UNITED STATES
NUCLEAR REGULATORY COMMISSION
WASHINGTON, D.C. 20545

PACIFIC GAS AND ELECTRIC COMPANY
DIABLO CANYON NUCLEAR POWER PLANT, UNIT NO. 1
DOCKET NO. 50-275
AMENDMENT TO FACILITY OPERATING LICENSE

Amendment No. 71
License No. DPR-80

ATTACHMENT TO LICENSE AMENDMENT NOS. 71 AND 70
FACILITY OPERATING LICENSE NOS. DPR-80 AND DPR-82
DOCKET NOS. 50-275 AND 50-323

FIGURE 3.2-3a

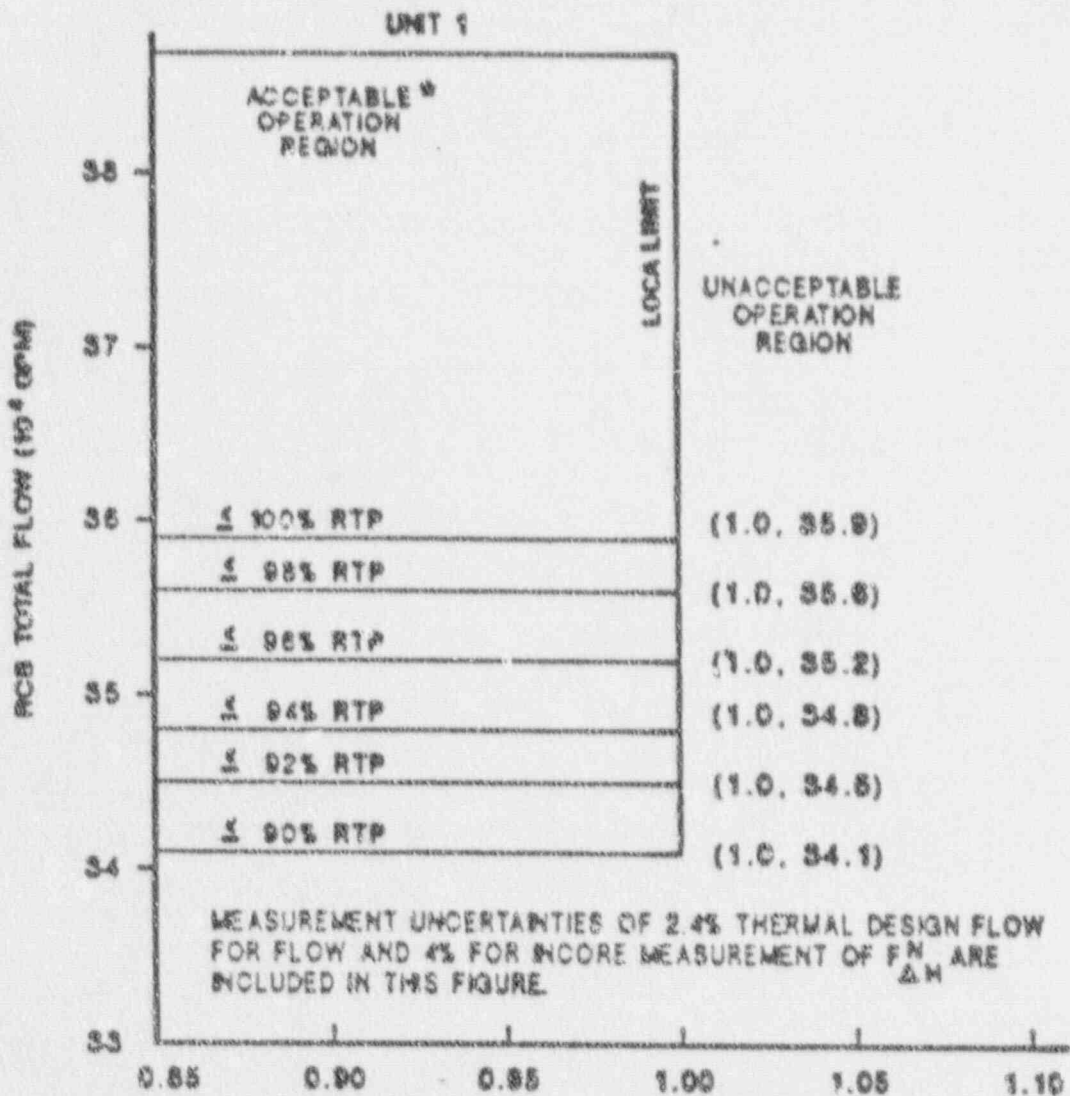
3.2.3 The combination of indicated Reactor Coolant System (RCS) total flow rate and R shall be maintained within the region of allowable operation shown on Figure 3.2-3a for Unit 1 and Figure 3.2-3b for Unit 2 for four loop operation.

c. $F_{\Delta H}^N$ = Measured values of $F_{\Delta H}^N$ obtained by using the movable incore detectors to obtain a power distribution map. The measured values of $F_{\Delta H}^N$ shall be used to calculate R since Figure 3.2-3a for Unit 1 and Figure 3.2-3b for Unit 2 include measurement uncertainties of 2.4% for flow and 4% for incore measurement of $F_{\Delta H}^N$.

With the combination of RCS total flow rate and R outside the region of acceptable operation shown on Figure 3.2-3a for Unit 1 and Figure 3.2-3b for Unit 2:
